HISTORIC AND DESIGN REVIEW COMMISSION

HDRC CASE NO: 2016-240

ADDRESS: 133 CEDAR ST

TYPE OF WORK: Landscaping for previously approved new construction

Cedar at Pereida - Landscape Narrative

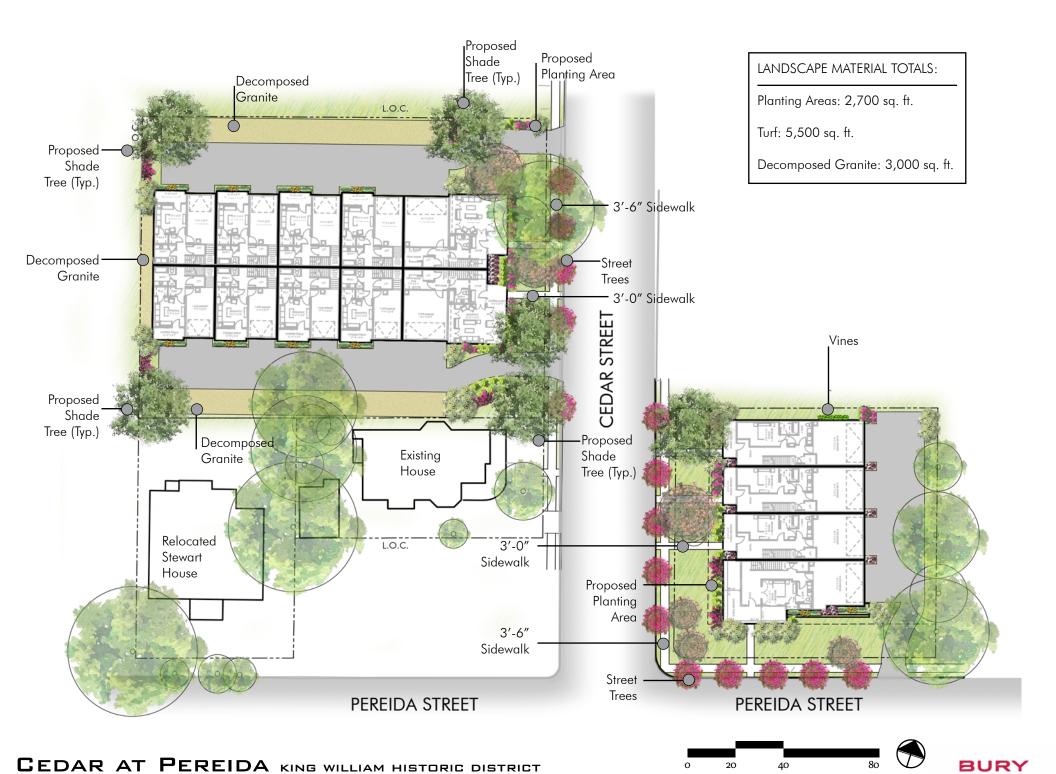
- b. At the corner of Cedar and Perieda, the applicant has proposed landscaping elements that include Crape Myrtles in the planting strip along the public right of way on both Cedar and Perieda, a live oak tree on the northern edge of the property, front yard lawn areas, public right of way sidewalks that are 3' 6" in width, on site sidewalks that are 3' 0" in width and planting beds in front of each unit with various native plants. The applicant's proposed landscaping materials and their placement is consistent with the Guidelines for Site Elements.

- c. On Cedar, the applicant has proposed landscaping elements that include Crape Myrtles in the planting strip along the public right of way, live oak trees on the north, west and south sides of the site, front yard lawn areas, public right of way sidewalks that are 3' 6" in width, on site sidewalks that are 3' 0" in width, a northern, western and southern border of decomposed granite and planting beds in front of each unit with various native plants. The applicant's proposed landscaping materials and their placement is consistent with the Guidelines for Site Elements.

Staff recommends approval as submitted based on findings a through c.
